FEC Degrade Monitor proposal for 50G and 100G

IEEE 802.3cd ad-hoc, April 26, 2017

Comment #85 against D1.2

CI 134 SC 134.5.3.3 P149 L49 # 85
Slavick, Jeff Broadcom Limited

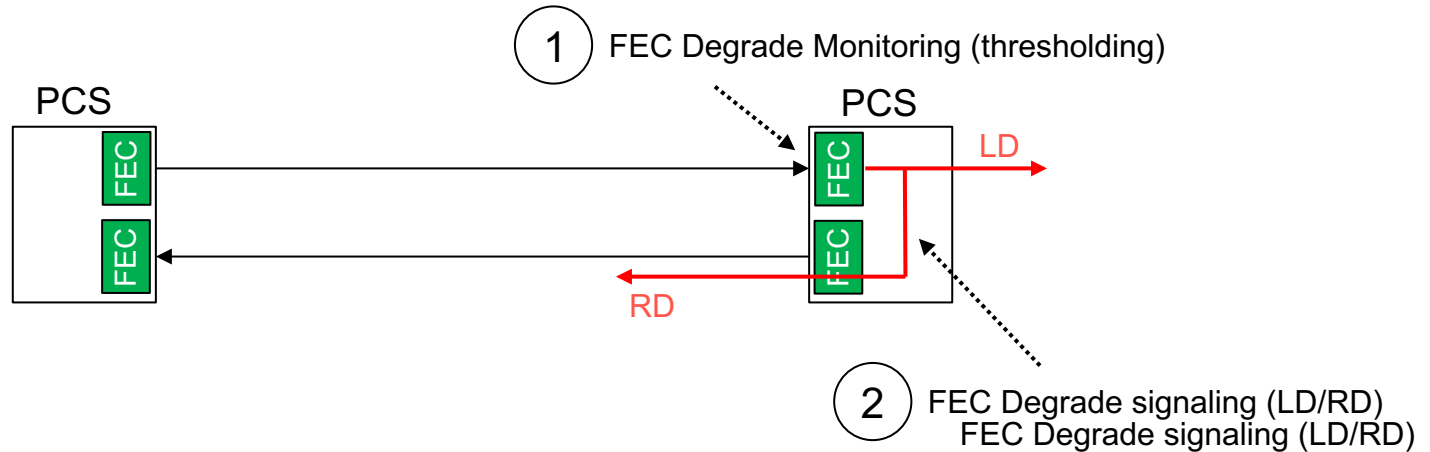
200/400G has added an optional feature to it's RS-FEC, degrade monitor. It's optional so maybe we should add it for 50G as well.

Add just the monitor by copying the last two paragraphs of 119.2.5.3 to the end of 134.5.3.3, changing PCS lanes to FEC lanes, add the appropriate MDIO registers for a degrade function outside of a PCS and the MDIO mappings to Table 134-1 and 134-2. No signalling of the status to be added, just the monitor. So it'd be an optional feature with status only available at one end of the link.

REJECT.

Counters already exist to monitor the RS-FEC performance.

The proposed remedy is not consistent with 100G (not supported), nor is it consistent with the FEC degrade feature added for 200G/400G in 802.3bs (no signalling).

There is no consensus to implement the suggested remedy. However, there is interest in more discussion in this capability for 100G and 50G. Detailed presentations are invited.
